**THE TOWN OF UXBRIDGE, MASSACHUSETTS  
ROADWAY & INTERSECTION IMPROVEMENTS PROJECT  
DOUGLAS STREET (ROUTE 16) AT  
WORCESTER-PROVIDENCE TURNPIKE (ROUTE 146)  
CONTRACT 2022-14**

**ADDENDUM #2  
March 16, 2022**

TEMPORARY ROADWAY PAVEMENT AREA

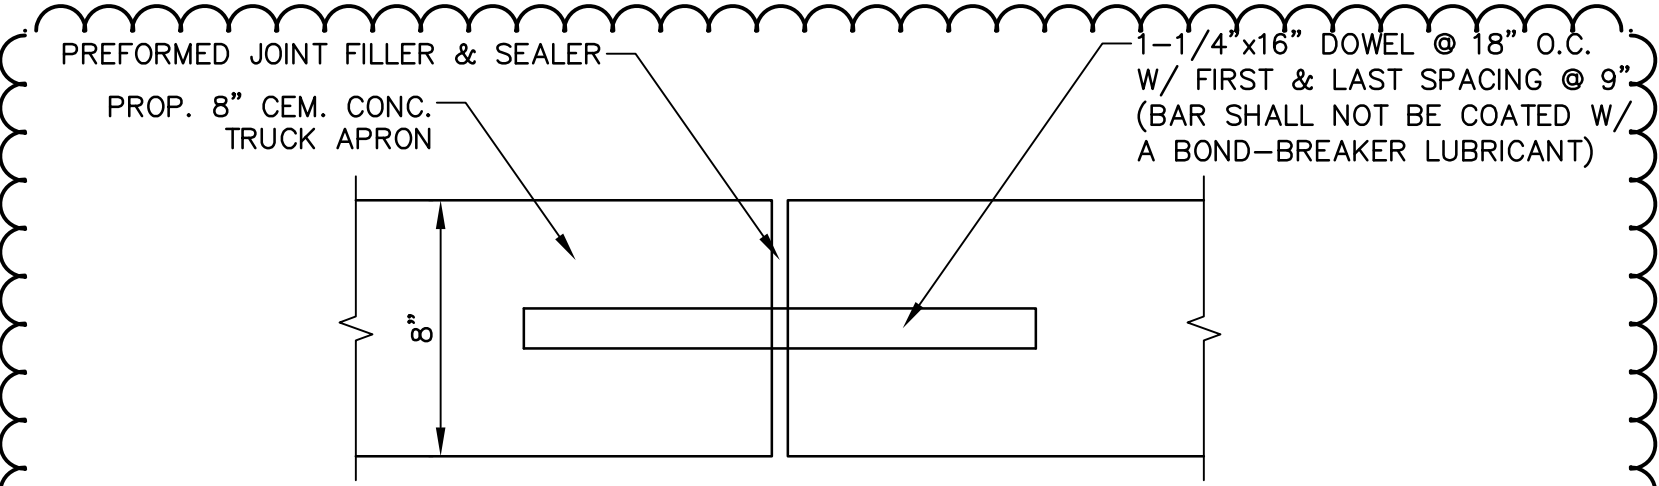
*A “Temporary Roadway Pavement Area” section has been added to the Pavement Notes that specifies the proposed hot mix asphalt types and thicknesses. The previous note pertaining to temporary paved areas has been stricken out. A new “Detail for Truck Apron Traverse Expansion Joint” and a new “Detail for Longitudinal Joint at Beveled Granite Curb” have been added to this sheet. In addition, the existing “Detail for Concrete Truck Apron” has been revised to incorporate and note the said longitudinal joint detail.*

**Question 52:** *The temporary paved areas are shown as a hatched area on the traffic management plans. The pavement sections do not specify HMA thicknesses and types for this work. Does the detail on Sheet 8 of 106 "Detail for Temp. Trench Patching in Full Depth Construction Areas apply to these hatched areas"? Please provide a "Temporary Paved Area" section detail with mix types and thicknesses.*

**Response:** A "Temporary Roadway Pavement Area" section has been added to the Pavement Notes on Sheet 6 of 106 that specifies the proposed hot mix asphalt types and thicknesses.

**ADDENDUM #2**  
**(MARCH 16, 2022)**  
**ADDED DETAILS**

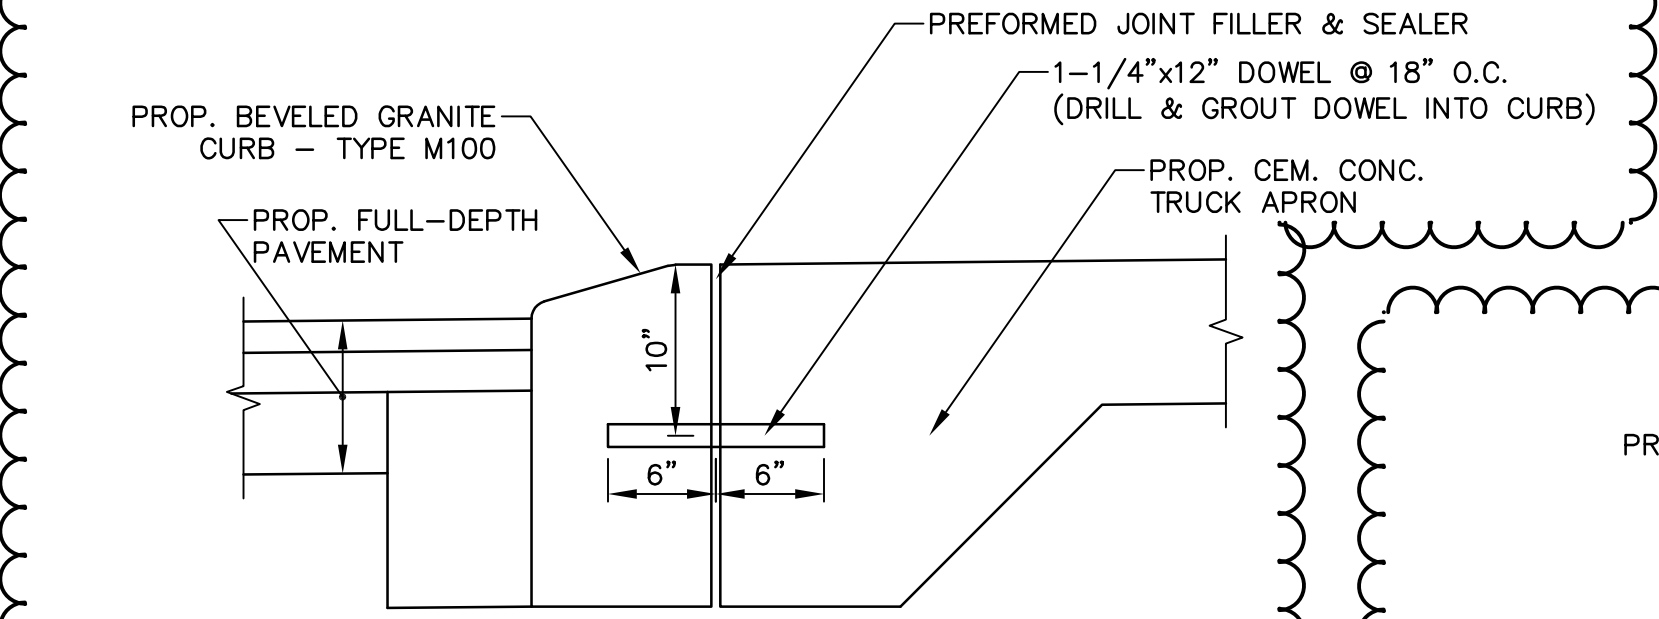
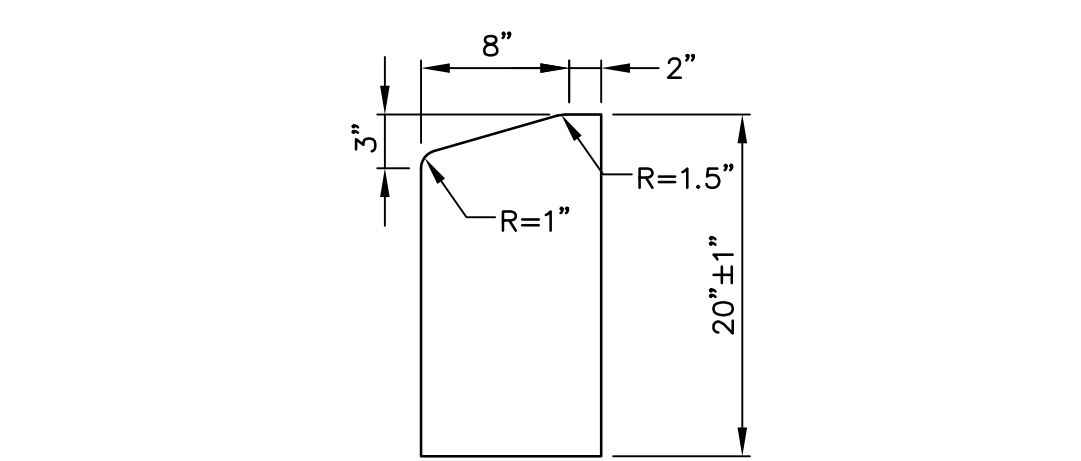
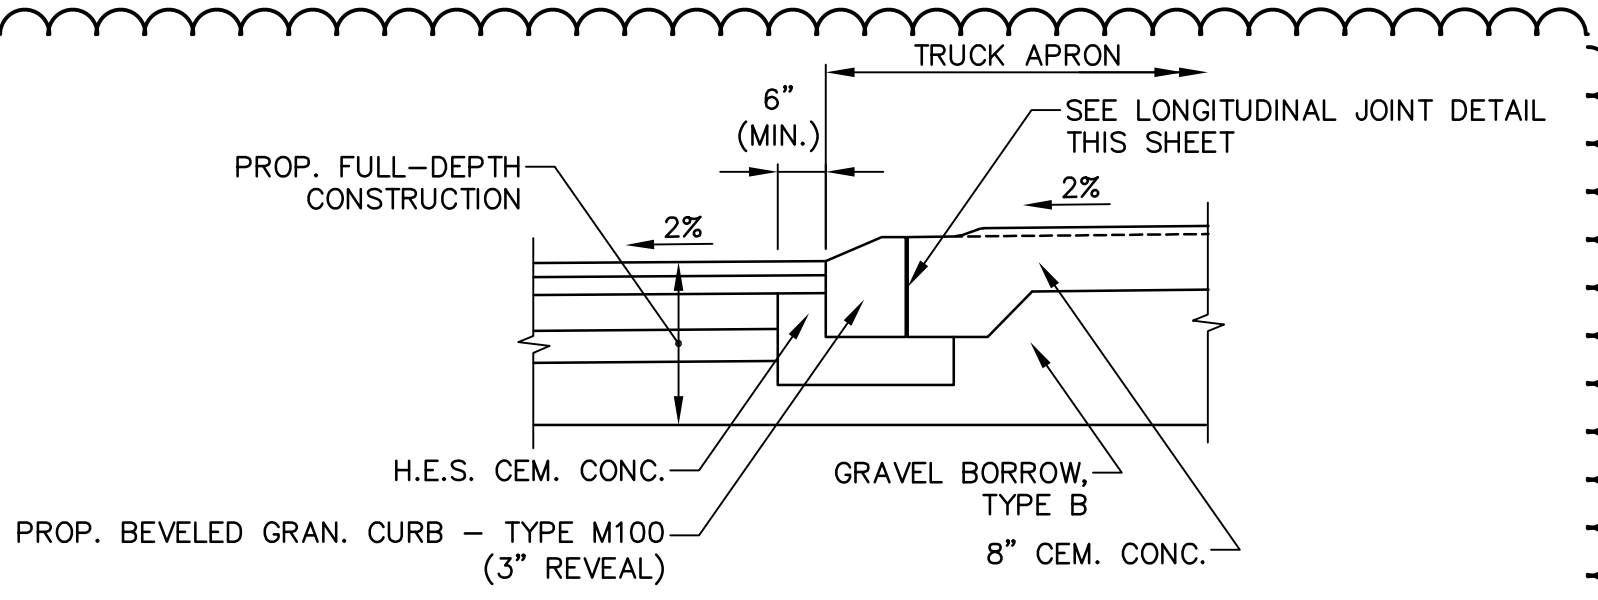
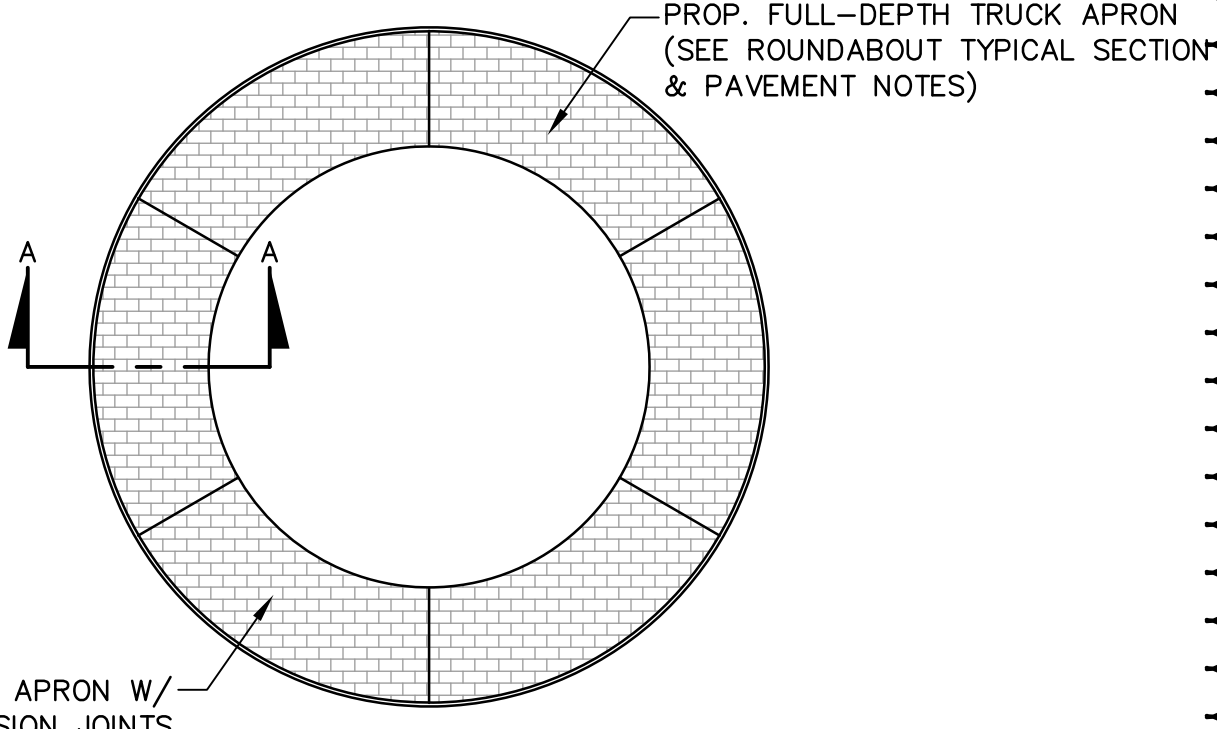
**Question 34:** *Item 701.31 - Stamped Cement Concrete Truck - detail on plan sheet 6 of 106 states contraction and expansion joints. Please provide details of each joint type. If dowels are required please provide size, spacing, epoxy or plain and pay item used for compensation?*

**Response:** Joint details have been added to the Construction Details on Sheet 6 of 106.

**DETAIL FOR TEMPORARY TRENCH PATCHING  
IN FULL-DEPTH CONSTRUCTION AREAS**  
NOT TO SCALE

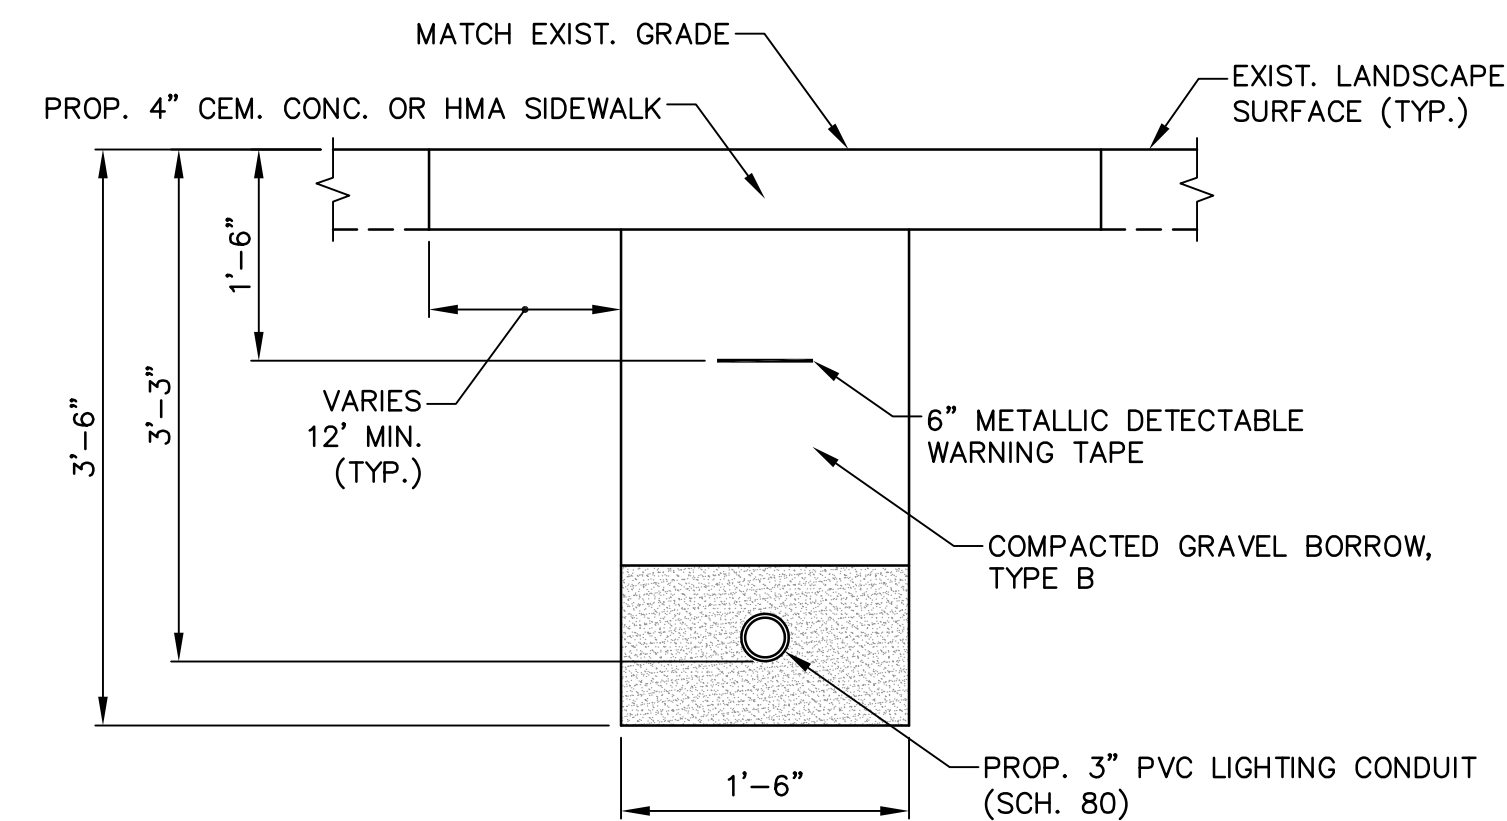
*The “Detail for Conduit Under Roadway in Milling & Resurfacing Areas” has been replaced by a new detail entitled “Detail for Temporary Trench Patching in Full-Depth Construction Areas”. In addition, the existing “Detail for 24”x13”x36” Electric Handhole” has been revised to indicate the conduit and bell ends shall be PVC.*

**DETAIL FOR 24"x13"x36" ELECTRIC HANDHOLE**  
(MASSDOT STD. DWGS. SD2-022)  
NOT TO SCALE

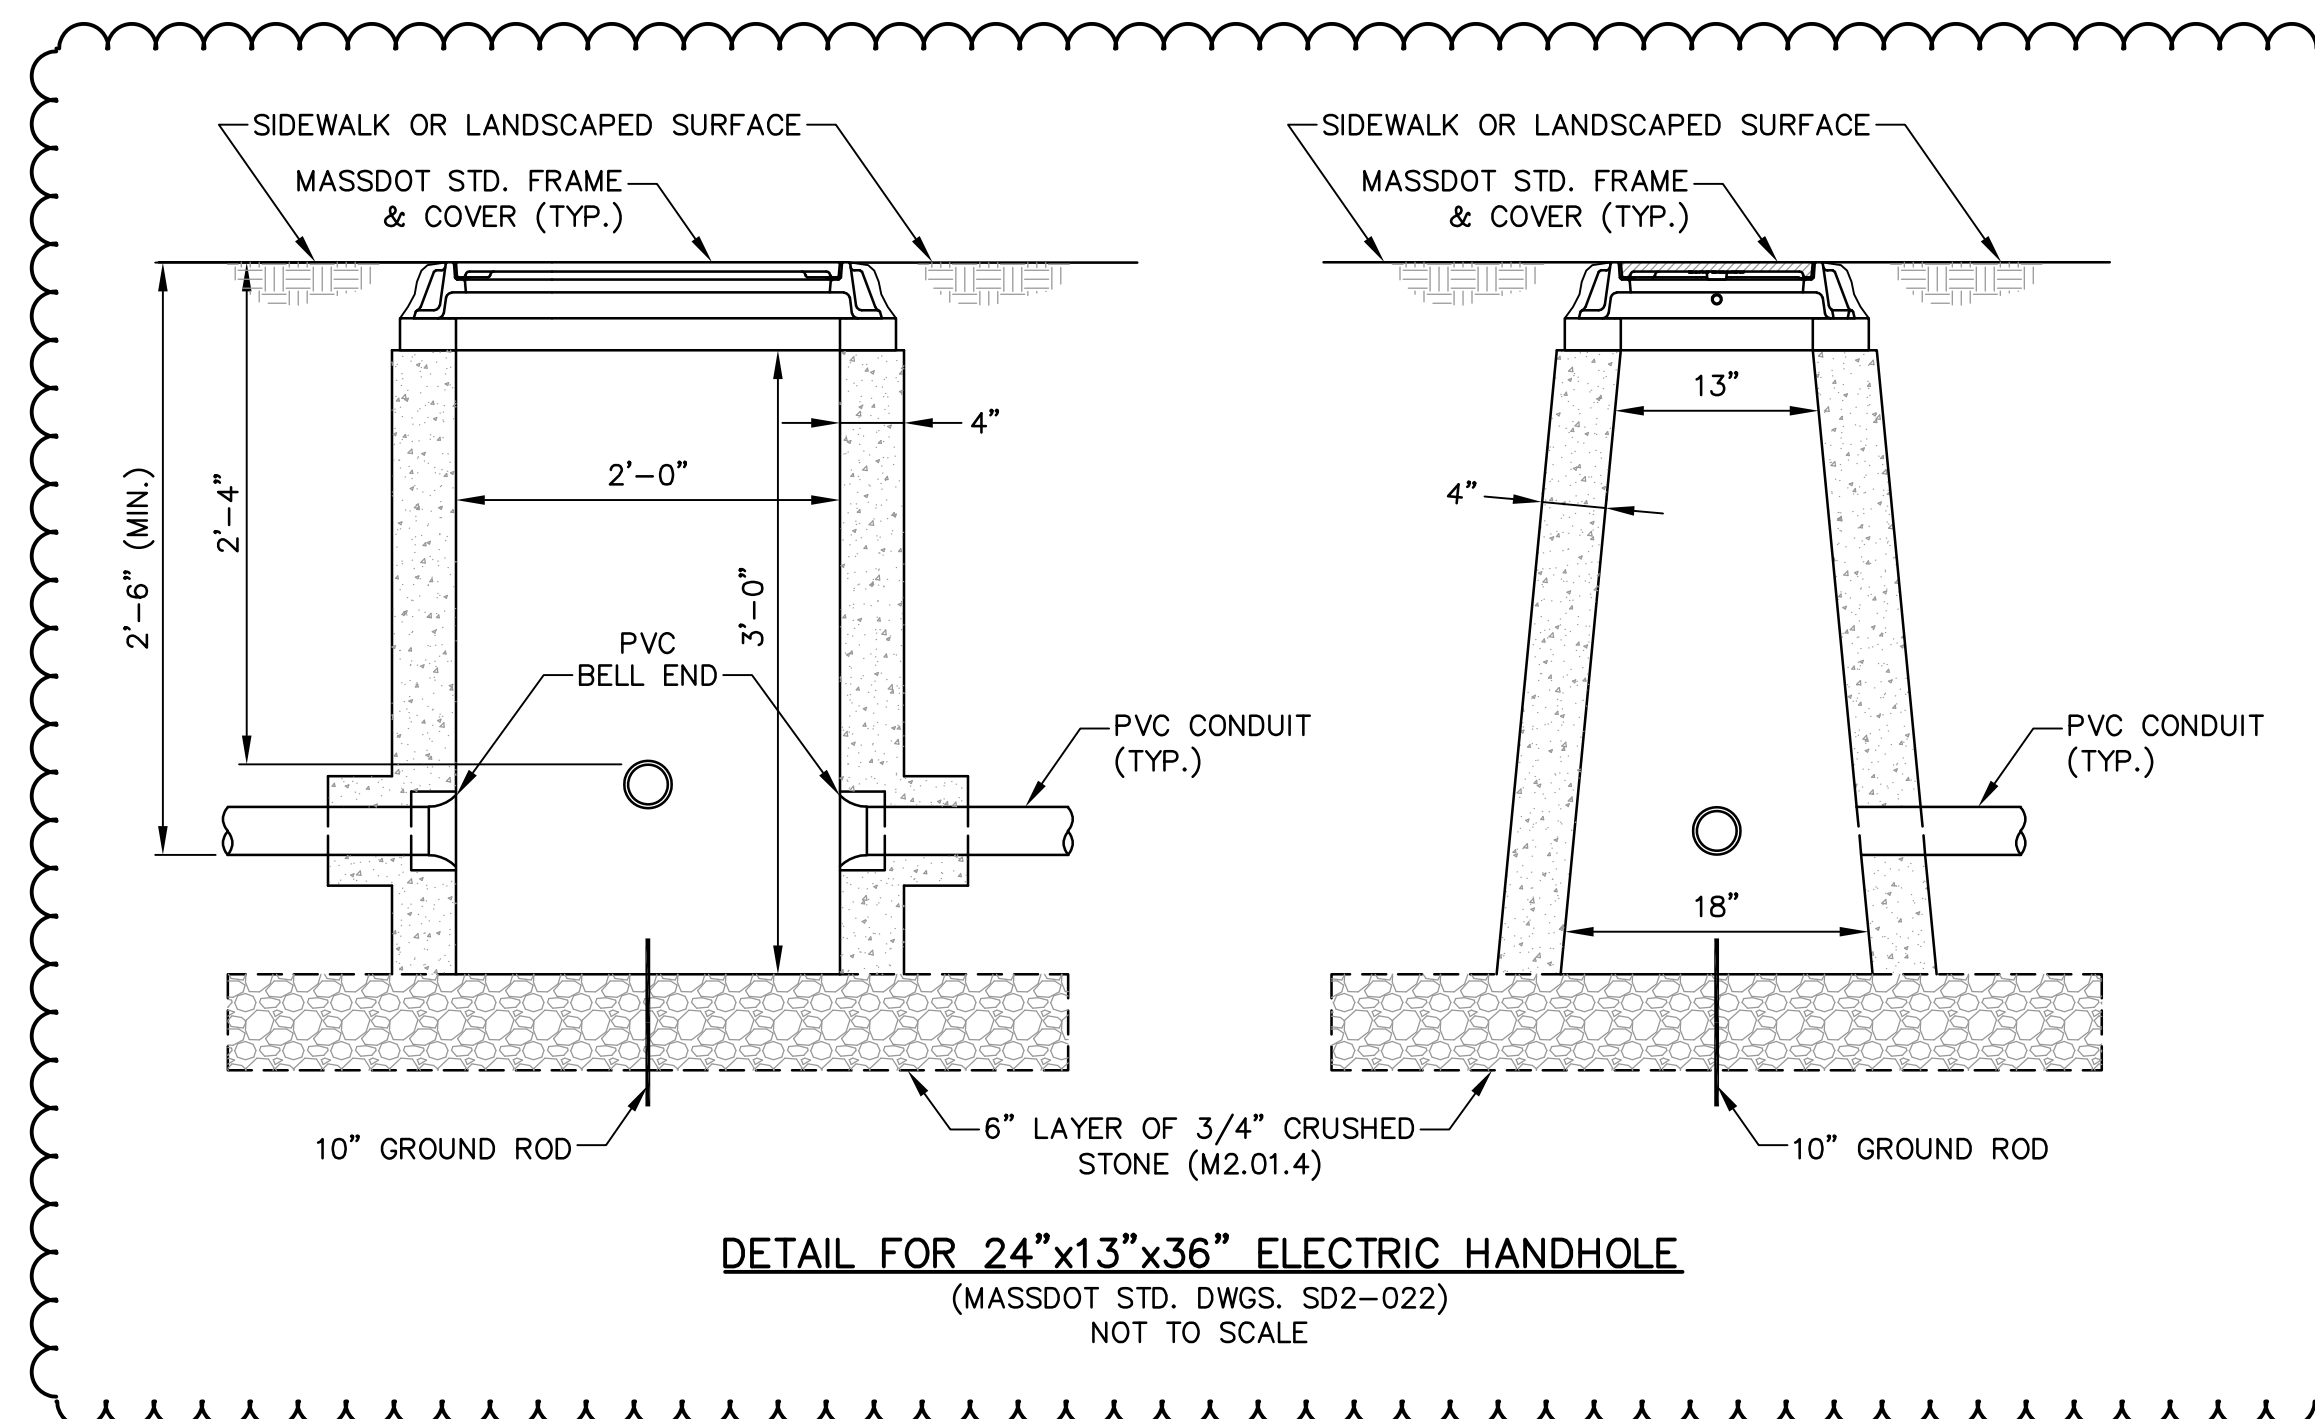
**Question 67:** *Plan Sheet 57, detail for the 24"x13"x36" handhole shows the pvc conduit entering the handhole with a bell end. Detail "Typical Handhole/Conduit Detail" on plan sheet 58 calls for "Rigid Steel at Sweeps". What is desired for the materials—PVC pipe with bell ends or Galvanized Rigid steel at the handholes? The price of steel is considerably more than just PVC bell ends.*

**Response:** Plan Sheet 57 of 106 has been revised. Conduit and bell ends entering the electric handholes shall be PVC. Rigid metal sweeps are only required for risers at utility poles and light pole foundations.
